FIRE SAFETY INSPECTION REPORT

MARK DESIGNERS LTD.

June 8, 2014

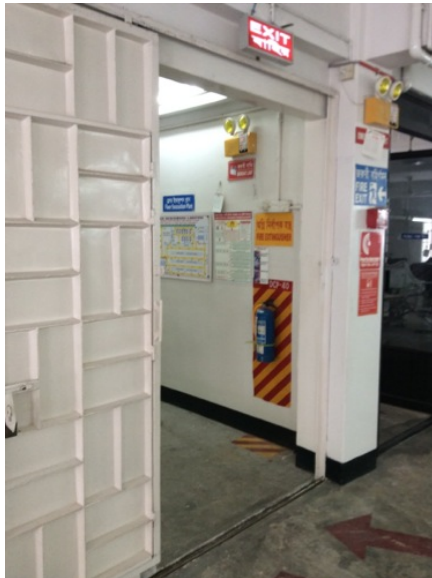
No.	Category	Finding	Recommendation	Remediation Timeframe
F-1	Fire Rated Construction	The boiler, transformer and fire pump rooms are not separated by fire-rated construction (openings, non-rated doors, penetrations). The shed is open to gas pipe line and storage room.	Separate the boiler, transformer and fire pump rooms by a minimum 2-hr fire-rated construction. Seal and or protected all openings to maintain the required fire separations	Within 3 months

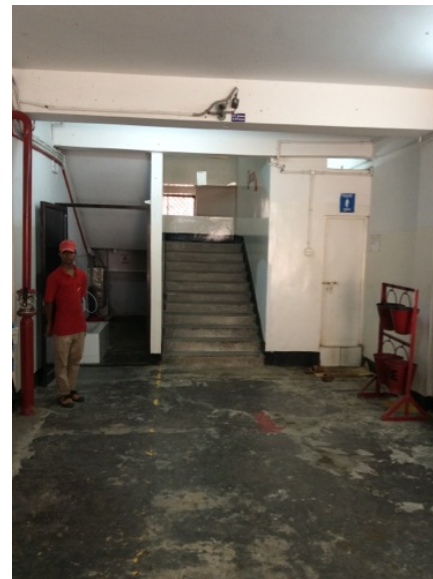
F-11	Egress	Handrails are not provided in all exit stairs on the ground floor.	Provide handrails on at least one side of exit stair.	Within 3 months
------	--------	--	---	-----------------

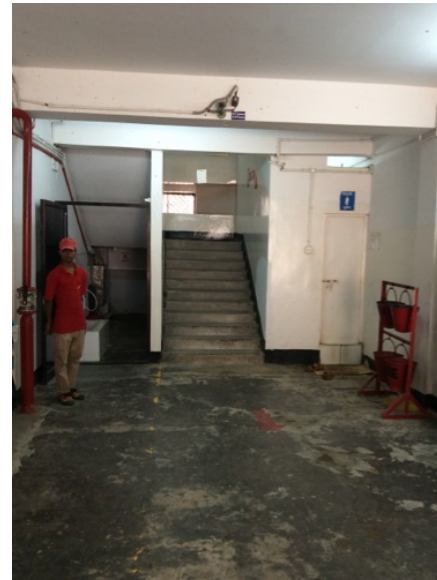
F-12	Egress	All exit stairs discharge inside the building.	Provide 2-hr fire-rated exit passageway leading directly outside (vestibules to separate any storage areas) or Provide sprinkler protection for discharge floor in accordance with NFPA 13.	Within 6 months
------	--------	--	---	-----------------
